SUBJECT: PERRY NUCLEAR POWER PLANT, UNIT NO. 1 - ISSUANCE OF
AMENDMENT REGARDING TECHNICAL SPECIFICATION CHANGES TO
PERMIT INSTALLATION OF UPPER CONTAINMENT POOL GATE AND
DRAIN-DOWN OF REACTOR CAVITY PORTION OF UPPER CONTAINMENT
POOL (CAC NO. MF7476) (L-16-083)

Amendment No. 174
License No. NPF-58

SAFETY EVALUATION BY THE OFFICE OF NUCLEAR REACTOR REGULATION
RELATED TO AMENDMENT NO. 174 TO FACILITY OPERATING LICENSE NO. NPF-58

PERRY NUCLEAR POWER PLANT, UNIT NO. 1

Figure 3.10.9-1
Upper Containment and Suppression Pool Levels

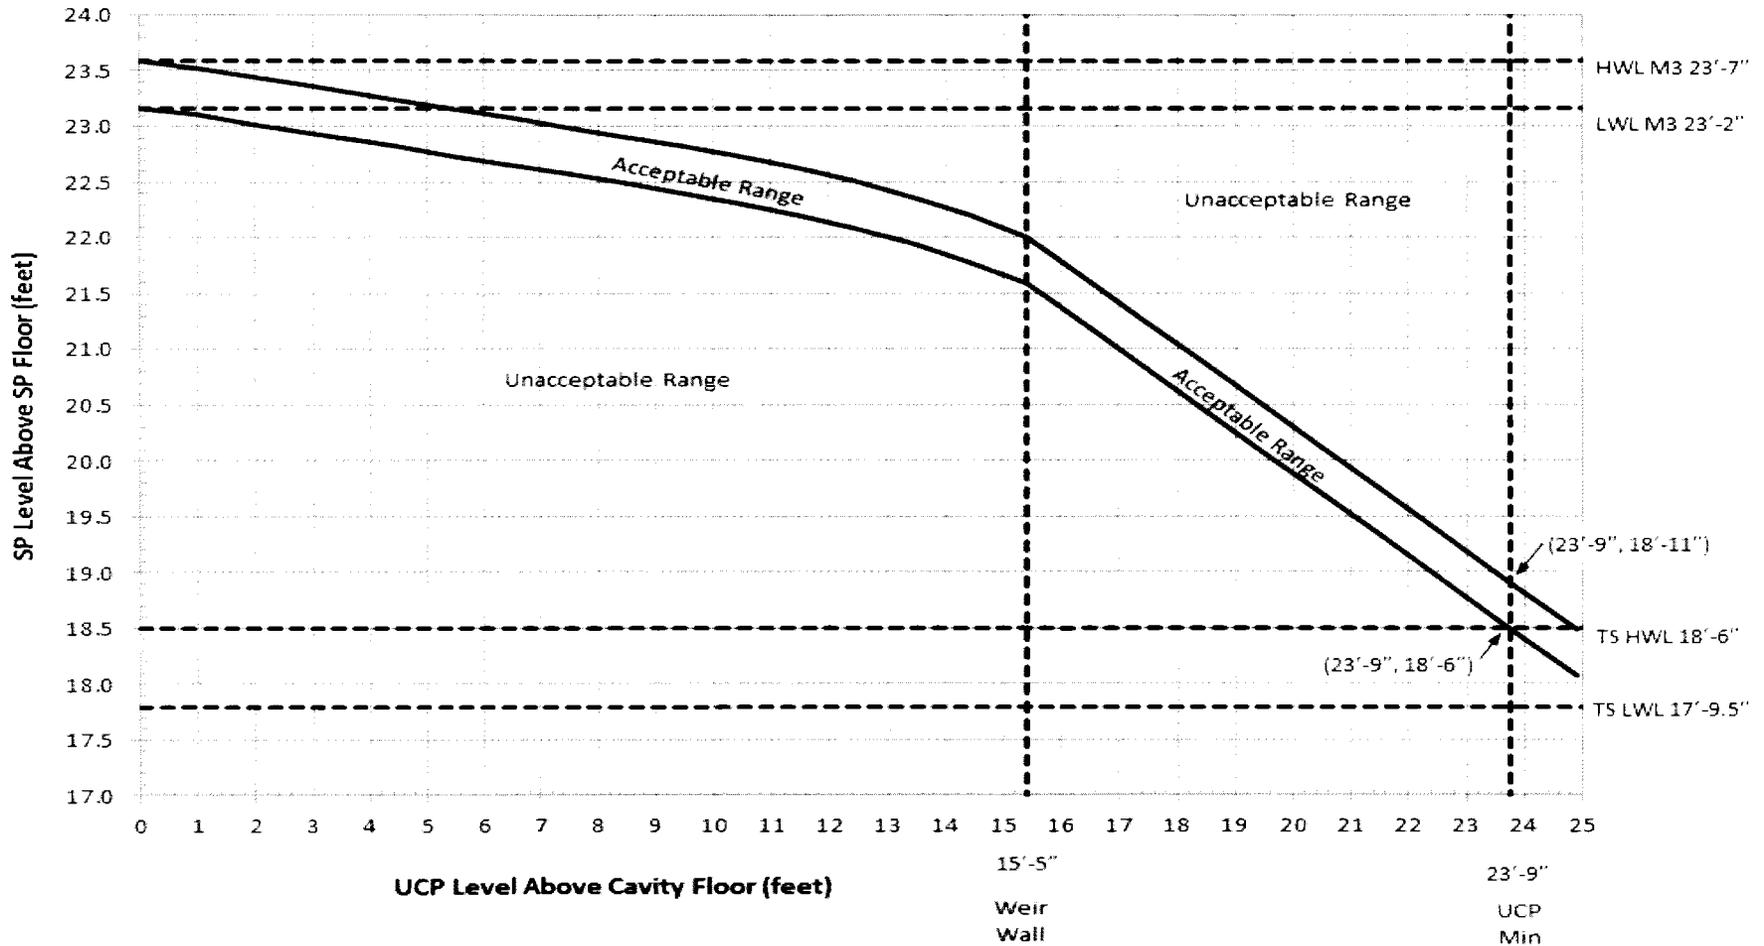
TS 3.10.9: The licensee proposes the creation of new TS 3.10.9, "Suppression Pool Makeup-MODE 3 Upper Containment Pool Drain-Down," including Figure 3.10.9-1, to suspend TS 3.6.2.2, "Suppression Pool Water Level," and TS 3.6.2.4, "Suppression Pool Makeup (SPMU) System," and to allow draining of the reactor well portion of the UCP in MODE 3 under certain conditions.

Figure 3.10-9-1, "Upper Containment and Suppression Pool Levels," is also added, but is not reproduced here. Figure 3.10.9-1 provides the acceptable range of suppression pool level above the suppression pool floor (in feet) as a function of UCP level above the cavity floor (in feet).

The suppression pool LWL will need to be increased by 5.4 inches + 0.3 inches (accounting for level instrument uncertainty) to a new lower limit of 18 feet 3.2 inches when the reactor well to steam dryer storage pool gate is installed in MODES 1, 2, and 3. If the MODE 3 drain-down of the reactor cavity portion of the UCP is conducted, the suppression pool LWL will need to be increased in accordance with new TS Figure 3.10.9-1.

If the MODE 3 drain-down of the reactor cavity portion of the UCP is conducted, the suppression pool HWL will need to be increased in accordance with new TS Figure 3.10.9-1.

- a. Suppression pool average temperature is $\leq 110^{\circ}\text{F}$;
 - b. Suppression pool and upper containment pool water levels are maintained within limits of Figure 3.10.9-1;

The SRs associated with LCO 3.10.9 include verification of suppression pool temperature, reactor steam dome pressure, levels in the Acceptable range of Figure 3.10.9-1, levels in the steam dryer storage pool and the fuel transfer pool areas of the UCP are sufficiently above the reactor vessel flange, location of the IFTS carriage, and closure of the IFTS transfer tube shutoff valve.
